Project:	<b>Highways England Spatial Planning Arrangement 2016-2020</b>	Job No:	<b>60600479 / DF006.001</b>
Subject:	<b>Aquind Interconnector – SRTM Data Analysis &amp; TA Scoping Note Review</b>		
Prepared by:	<b>Andrew Cuthbert</b>	Date:	<b>8<sup>th</sup> October 2019</b>
Checked by:	<b>Kelly Davis</b>	Date:	<b>10<sup>th</sup> October 2019</b>
Verified by:	<b>Liz Judson</b>	Date:	<b>11<sup>th</sup> October 2019</b>
Approved by:	<b>Andrew Cuthbert</b>	Date:	<b>14<sup>th</sup> October 2019</b>

- 1.1. This Technical Note documents the results of a review carried out by AECOM, on behalf of Highways England, of a number of documents supplied by WSP on 12<sup>th</sup> September 2019 in relation to the potential impact on the transport network of the construction phase of the proposed Aquind Interconnector. These documents have been provided prior to the submission of a Development Consent Order (DCO) application.

Figure 1: Junctions in the Study Area  
 (Source: SRTM DAR Appendix B)

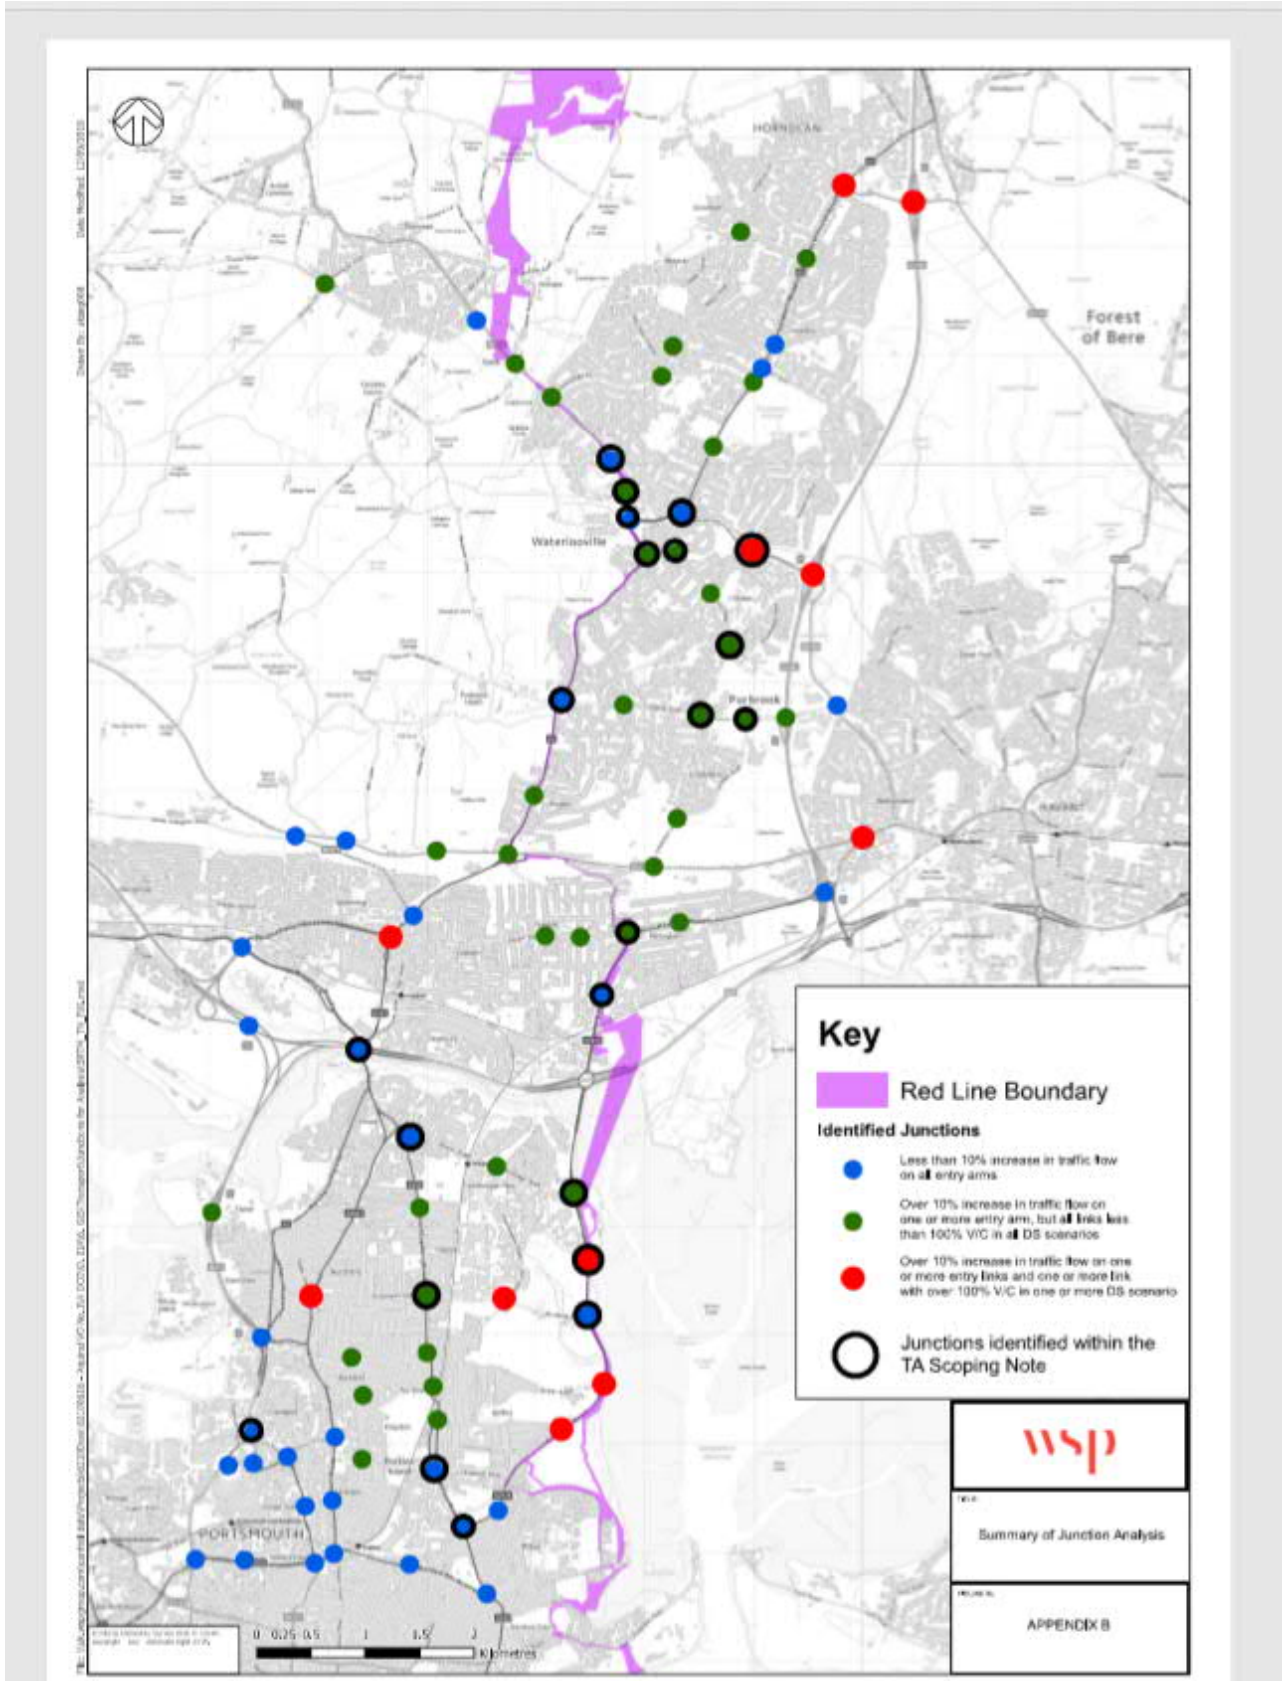
- 1.9. These locations are illustrated on the figure at Appendix B of the SRTM DAR, a copy of which is reproduced at Figure 1 on the following page.

- 1.10. Examination of this Figure shows what looks like a works site access located off the A2030 immediately to the north of its junction with the A27, which might have the potential to give rise to an impact at the A27/ A2030 junction itself.

- 2.5. These are tabulated on pages 7 & 8 of the SRTM DAR and their locations are illustrated on Figure 1 of this TN.
- 2.6. The operation of the junctions has been assessed using the SRTM in an assessment year of 2026 in a number of scenarios. AECOM assume that this is the year in which peak construction activity will occur. No information is given in the SRTM DAR as to the duration of these effects, although this may be stated in the PEIR, which AECOM have not yet reviewed.

- 2.8. These junctions are identified by the use of red circles on Figure 1 of this TN.
- 2.9. The SRTM DAR gives details of key traffic flow increases, some of which are significant (the highest being 197 additional vehicles in the peak hour).

2. The existence or otherwise of a construction site access on the east side of the A2030, to the north of its junction with the A27 should be confirmed (para 1.10). If a site access is proposed here, further details should be provided as follows:

- o Its proposed layout, including HGV swept path analysis;
  - o Its capacity tested using a PICADY model;
  - o Confirmation that the risk of a queue back from this junction to the A27/ A2030 grade separated junction is minimal; and

- o If this is not the case, details of traffic management measures designed to minimise such queueing.
3. Details of the performance of the following junctions in each assessment scenario, extracted from the SRTM runs already undertaken (para 2.13):
